Dear Members of the Technical Advisory Committee,

RE: 2 Russell St
Meeting: TAC 09/06/22
Packet Pages: 5 to 10 (page 20-395)

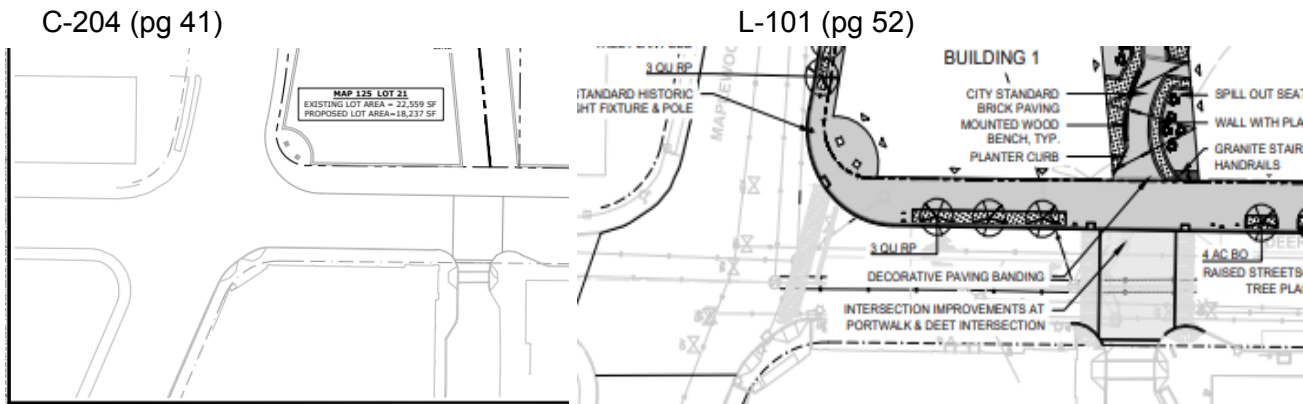
When comparing Pre and Post numbers the amount of “good” Pre is 29,047 sf (17.56%) vs the Post 15,941sf (9.64%). This is a decrease of “good” of 7.92% about 13,101 sf. A significant increase in impervious surface on the entire lot! It was made clear that detention basins were increased in size. Re-reviewing the drainage plans show Pre-PA-2 (pg 90) described as running off into a **gravel swale**. Based on the description of Post PA-2 there will no longer be a swale due to needing to provide a 20’ wide fire lane. *The concern is that the RR tracks are highly impervious and usually sit higher than the gravel on each side of them.* This causes whatever water that collects between the tracks to run off onto each side. It seems the Post results of PA-2 will be pooling along the RR track and the proposed fire road in the summer, even with the slight grade. The snow walls from plowing, will likely encourage ice forming on the fire road. A man made swale to direct and control the flow of this water, which is shown flowing toward Maplewood, could be considered, with grating along the length of the fire road to allow water from melting snow and all the “sheet flow” mentioned in both the pre and post descriptions to sheet flow under this driving/walking/riding area.
